Integrated  
Environmental  
Solutions

February 4, 2005

Subject: L.E. Carpenter & Company (LEC), Wharton Borough, Morris County, New Jersey  
USEPA ID No. NJD002168748  
Response to Deficiency Letter for Application for Stream Encroachment Permit and  
Freshwater Wetlands Statewide General Permit No. 4  
File No.: 1439-04-0001.1 (FHA 040001 & FWW 040001)

### SITE WIDE CROSS SECTIONS

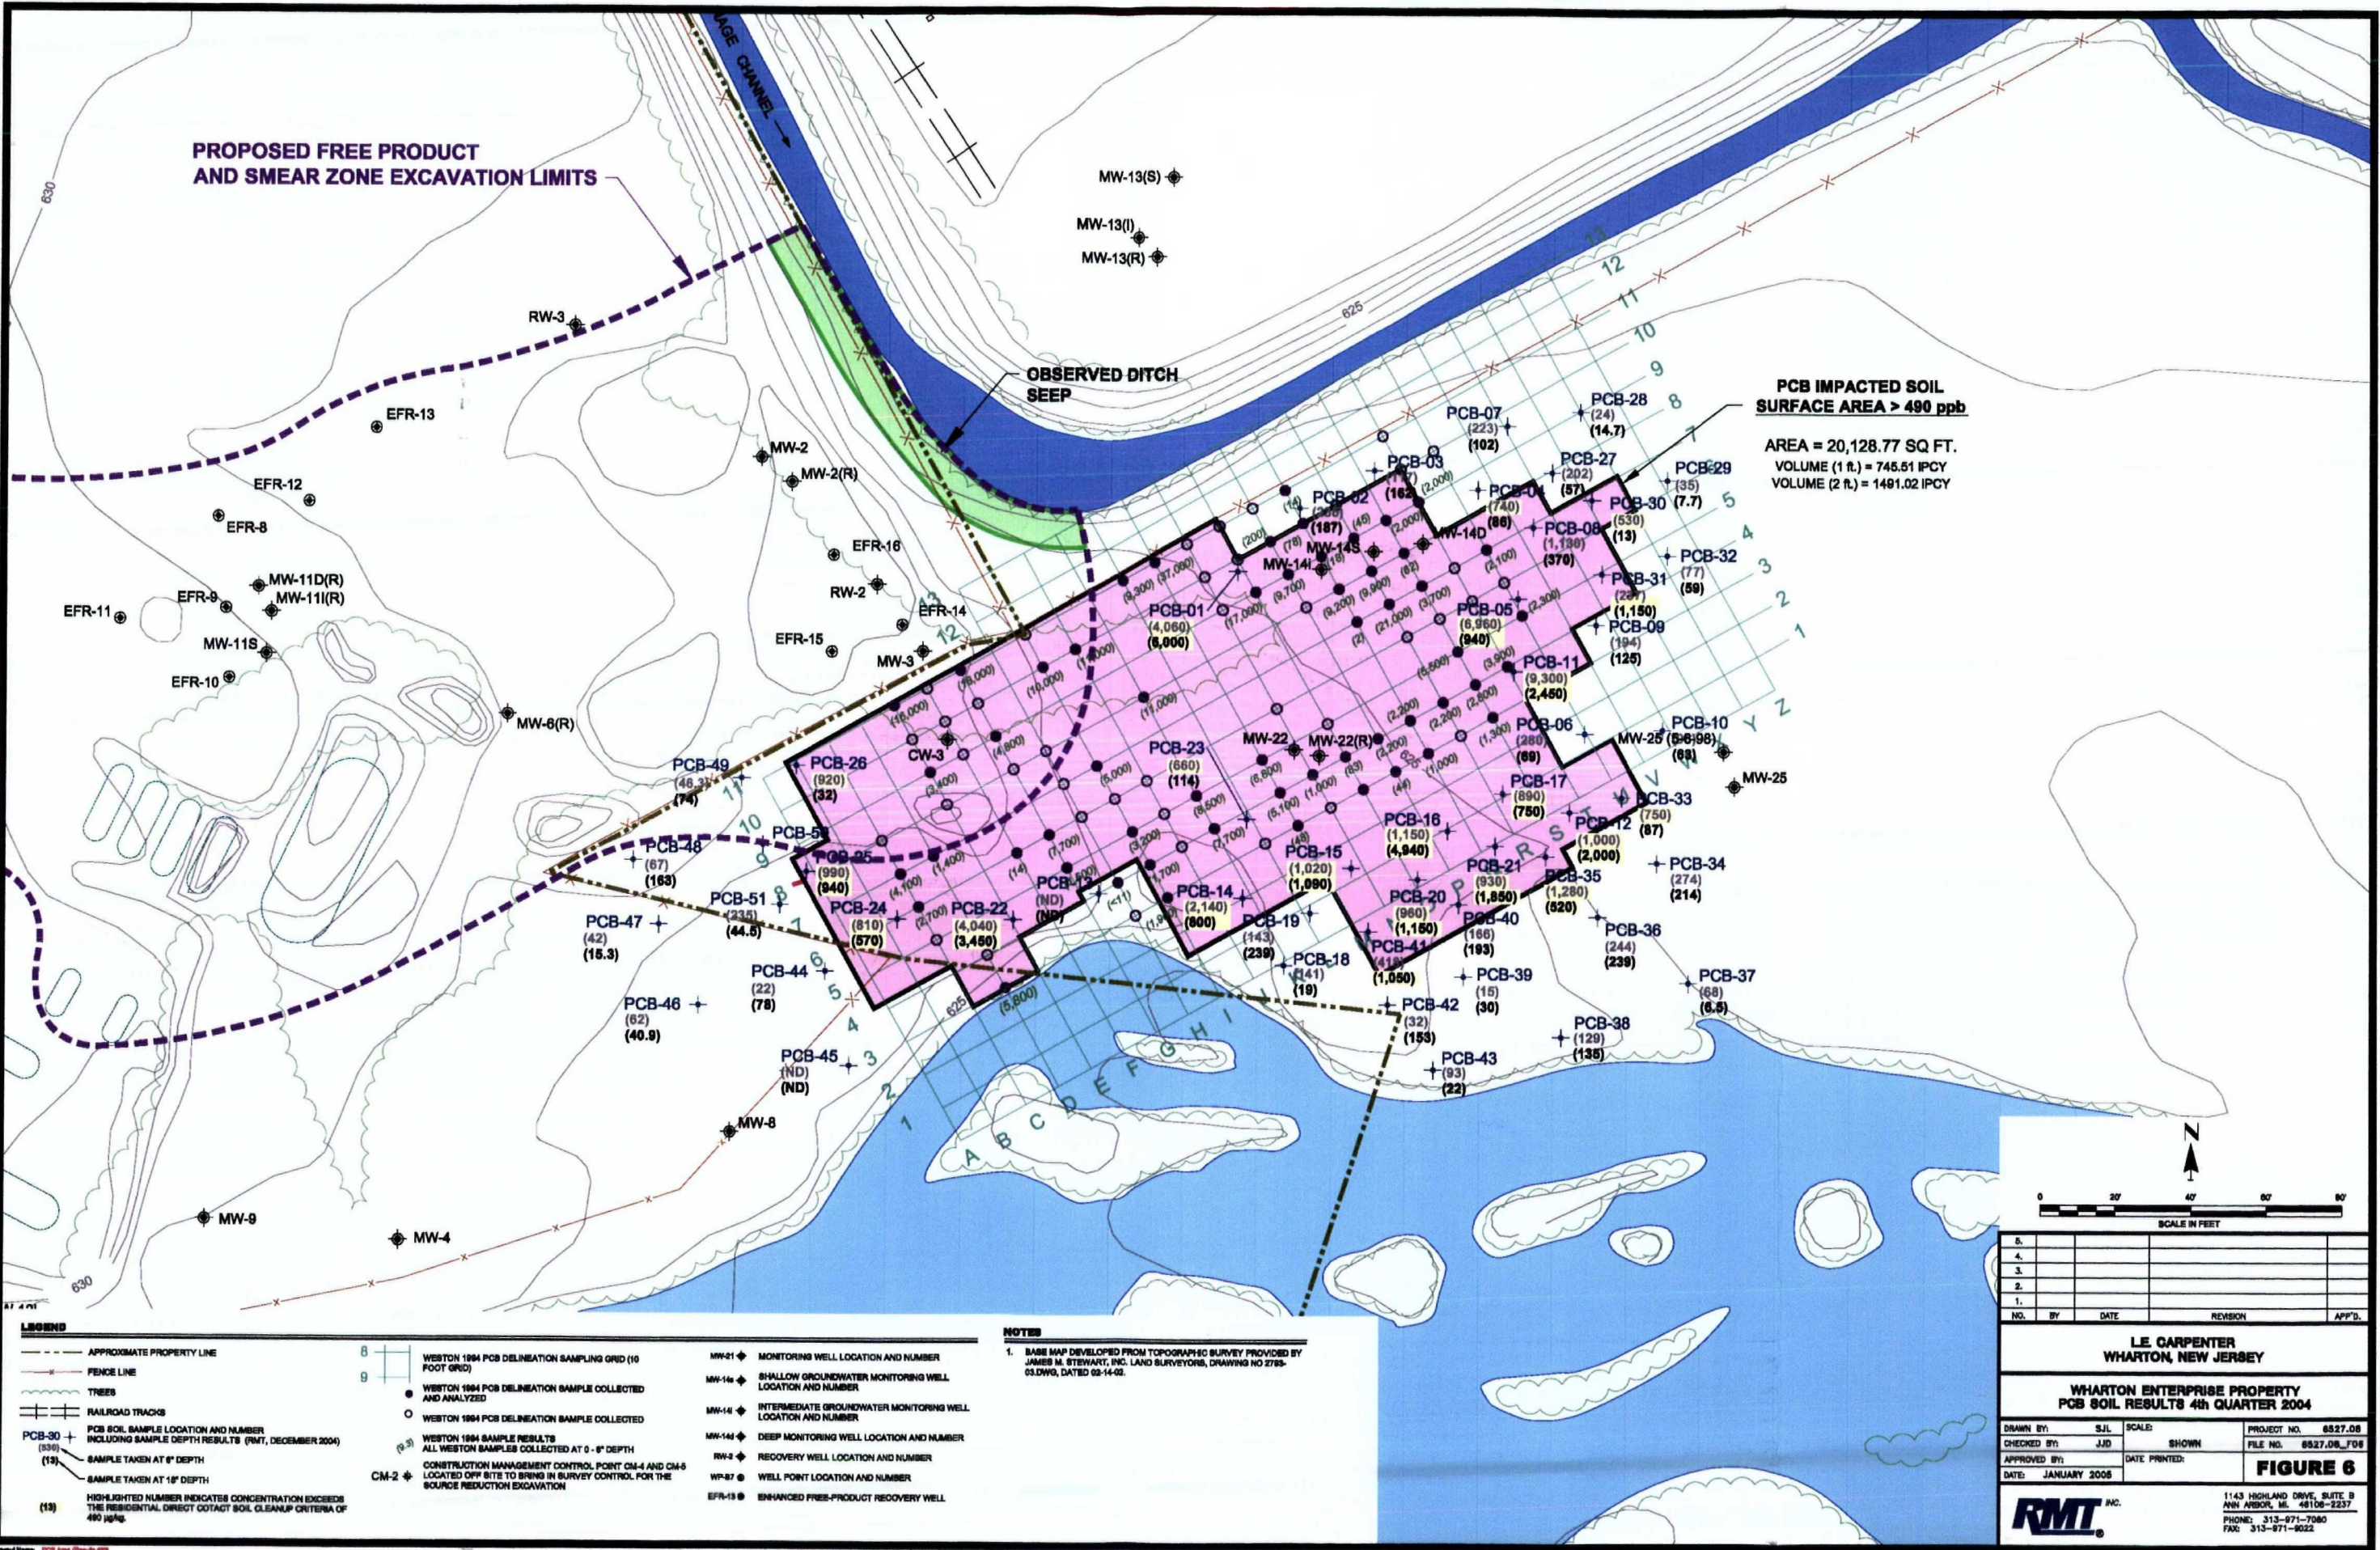
- g) The Program is concerned that use of a "solidified slurry monolith" may adversely affect proposed wetland restoration areas. It is also unclear from the plans where this type of material will be placed. Should the source of hydrology within the wetlands be surface water, you may create a perched system that holds more water than desired, creating an open water system rather than a wetland system. Conversely, if the source of hydrology for the wetlands is groundwater, you may prevent the rise of groundwater levels into the wetlands, therefore robbing the wetlands of hydrology and creating an upland system. Additional justification for the use of this material, and clarification on the plans as to where this is proposed, is required.

- g) The solidified low-permeability slurry monolith will not adversely effect the proposed wetland restoration area. The low-permeability slurry monolith will be emplaced across the LNAPL smear zone remediation area at an average thickness of about five feet. The slurry, which basically consists of a mixture of bentonite clay and Portland cement, will be emplaced within the subsurface only, as shown on the attached cross sections (Ref. revised Figure F8 presented in Attachment 2).

The slurry monolith is not expected to effect the subsurface groundwater discharges into the wetland for the reasons outlined below:

- (a) The amount of fine-grained matrix (silt and clay size particles) within the uppermost fifteen feet of native soils (unit described on the cross section as "coarse-grained soils with variable mixtures of cobbles, boulders, sand, silt, and clay") increases across the site from west to east (Ref. Attachment 3). This trend has been more recently verified by additional borings conducted in late 2004. This means that the slurry monolith is expected to have a permeability similar to the native soils in the area just west of the wetland area. Therefore, we expect no significant changes with respect to groundwater discharges to the wetlands, the ditch, and the river following replacement of subsurface contaminated soils with the slurry monolith.

- (b) Native soils within the wetland already consist predominantly of native silty clay that occurs from the ground surface to a depth of between 2-8 feet. In other words,

the hydrology within the wetland area is currently controlled partially (surface water also controls the wetland hydrology) by groundwater that flows through soils with a substantial clay content (see eastern end of cross sections shown in Attachment 3).
